Serial No 19-282B
NRA/SS R1
Docket No. 50-336
License No. DPR-65

DOMINION ENERGY NUCLEAR CONNECTICUT, INC.
MILLSTONE POWER STATION UNIT 2
SUPPLEMENT TO PROPOSED LICENSE AMENDMENT REQUEST TO REVISE TS
3.8.1.1, "A. C. SOURCES – OPERATING," TO SUPPORT MAINTENANCE AND
REPLACEMENT OF THE MILLSTONE UNIT 3 'A' RESERVE STATION SERVICE
TRANSFORMER AND 345 KV SOUTH BUS SWITCHYARD COMPONENTS

Figure 1
Millstone Station AC Power System

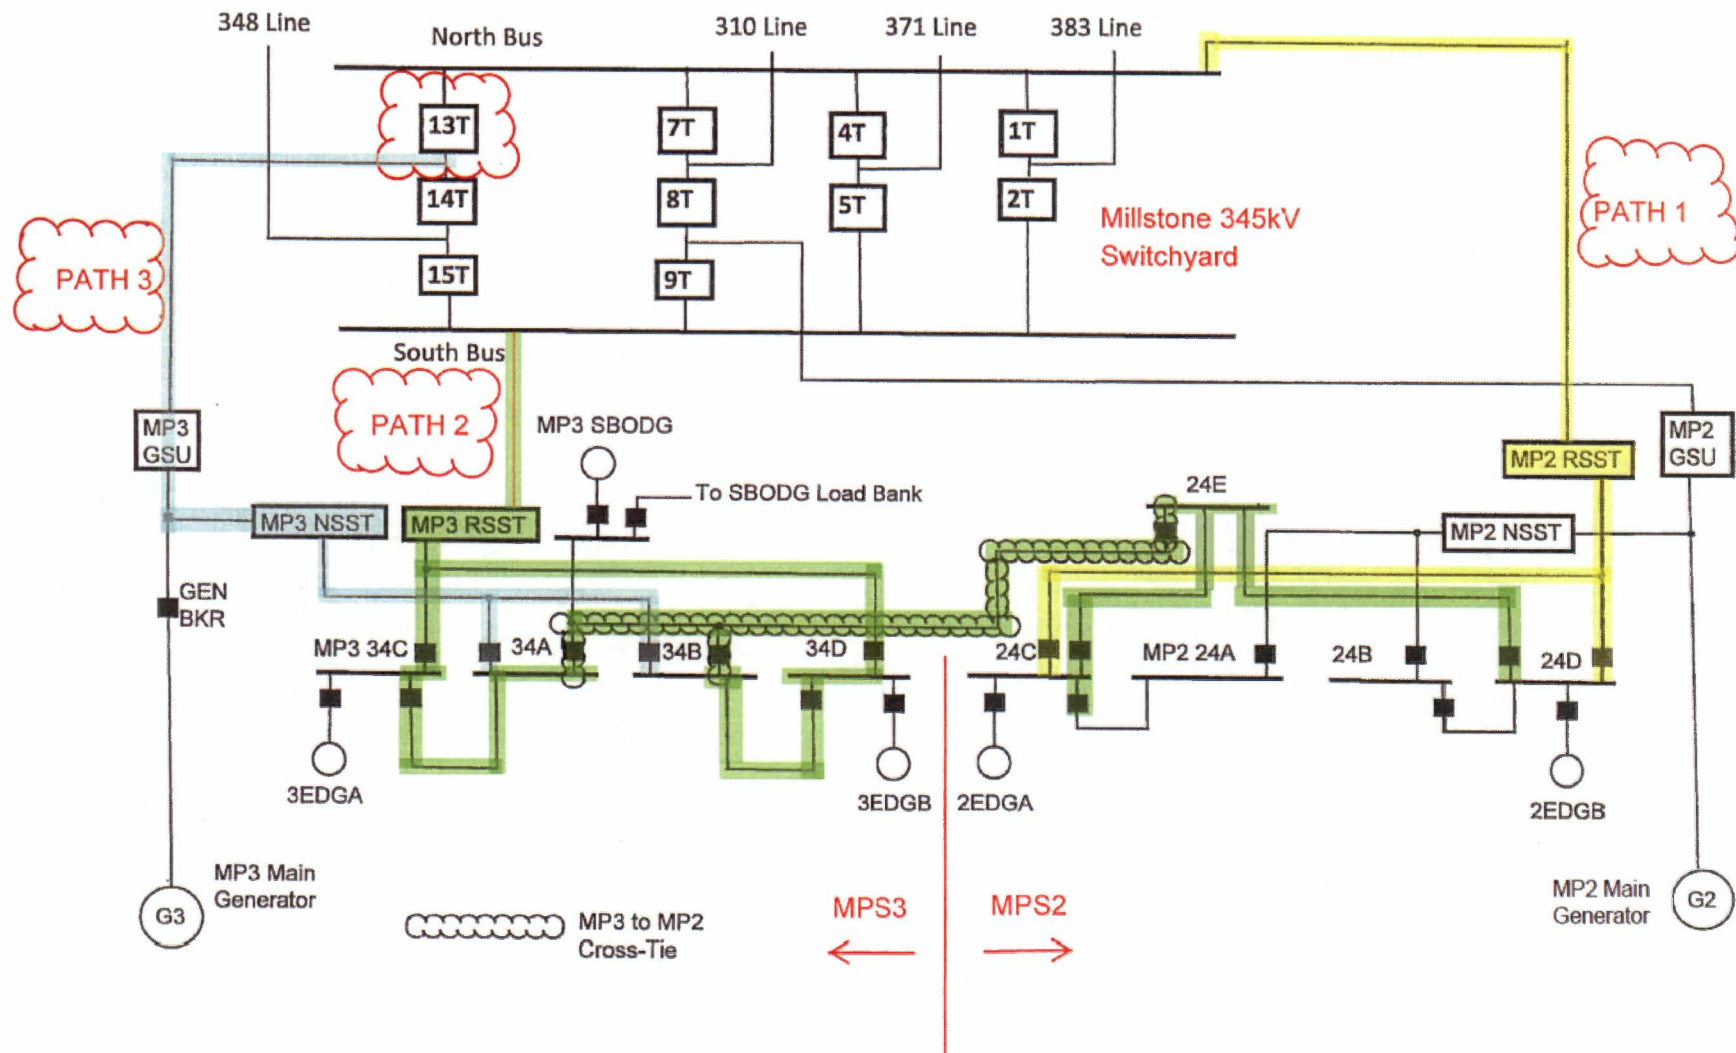
- MPS2 is assumed to be at full power operation.
- MPS3 is in cold shutdown, refueling mode or defueled.
- MPS3 'A' RSST is unavailable ("Path 2" on Figure 1).
- Switchyard breaker 13T is closed
- The south bus is de-energized and 345 kV line 310 is assumed to be out of service.

- Both MPS2 offsite power sources will be energized through two separate paths (as highlighted on Figure 1) and available for use as follows:
 - Preferred offsite power supply-powered from the MPS2 RSST ("Path 1" on Figure 1).
 - Alternate offsite power supply-from MPS3 to MPS2 cross-tie powered from MPS3 'A' NSST ("Path 3" on Figure 1).

Figure 1 shows the MPS electrical distribution system. The MPS3 SBO diesel generator (noted as "MP3 SBODG" on the Figure 1) output breaker ties to MPS3 Buses 34A, 34B or MPS2 Bus 24E. The normal buses feed their corresponding emergency buses by a Class 1E tie breaker. Control for closing feeder breakers to the 34A and 34B buses is available at MPS3 main control board and/or locally at the switchgear. Control for closing the feeder breaker to Bus 24E is available at the MPS2 main control board.
